# Staff Report Z-129-24-3 December 11, 2024

<u>North Mountain Village Planning</u> <u>Committee</u> Meeting Date:	December 18, 2024
Planning Commission Hearing Date:	January 2, 2025
Request From:	<u>C-2 M-R</u> (Approved <u>C-2 M-R</u> PKG/WVR) (Intermediate Commercial, Mid-Rise District, Approved Intermediate Commercial, Mid-Rise District, Parking Waiver) (11.76 acres), <u>C-2 M-R</u> (Approved <u>C-2 M-R SP</u> and <u>C-2 M-R</u> PKG/WVR) (Intermediate Commercial, Mid-Rise District, Approved Intermediate Commercial, Mid-Rise District, Special Permit and Approved Intermediate Commercial, Mid-Rise District, Parking Waiver) (0.56 acres), and <u>C-2 M-R</u> <u>DNS/WVR</u> (Intermediate Commercial, Mid-Rise District, Density Waiver) (0.14 acres)
Request To:	<u>C-2 M-R DNS/WVR</u> (Intermediate Commercial, Mid-Rise District, Density Waiver) (12.46 acres)
Proposal:	Multifamily residential, with a density waiver
Location:	Approximately 500 feet north of the northwest corner of 25th Avenue and Dunlap Avenue

#### 5. <u>Site Plan</u>

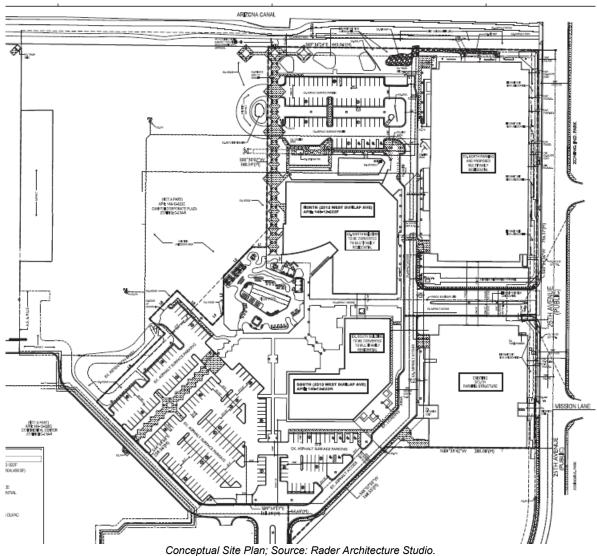
The proposal is for a 400-unit multifamily development. The proposal includes the adaptive reuse of two office buildings and one parking garage for multifamily residential use. The conceptual site plan, attached as an exhibit, depicts the site layout including the location of the north and south office buildings, the north parking garage, and the existing south parking structure. The proposal identifies the north and south office buildings, as well as the north parking garage, as proposed for conversion to multifamily residential use, while the south parking structure is not proposed for conversion.

Additionally, the site plan depicts the proposed new pool, pedestrian pathways, surface parking areas, open space area along the canal, existing bike racks, the landscape areas, and trash enclosure. The site will have two points of ingress/egress on 25th Avenue and on the existing private driveway to Dunlap Avenue on the southern end of the site.

To promote enhanced pedestrian and cyclist safety, convenience, and connectivity Stipulation No. 3 requires enhanced bicycle parking and infrastructure, Stipulation No. 7 requires shaded pedestrian pathways and Stipulation No. 6 requires pavement treatments that visually contrasts parking and drive aisles where pedestrian walkways cross a vehicular path.

- 4. A minimum 6-foot-wide pedestrian pathway shall be provided within the site, connecting to the Arizona Canal at the northwest corner of the site, 25th Avenue, and the "existing asphalt accessway" (at the south), as depicted on the site plan date stamped September 16, 2024, containing the following standards, and as approved or modified by the Planning and Development Department.

- 5. A minimum 10,500-square foot area shall be provided as publicly accessible open space, located in the northwest corner of the subject site as depicted on the site plan date stamped September 16, 2024, as approved or
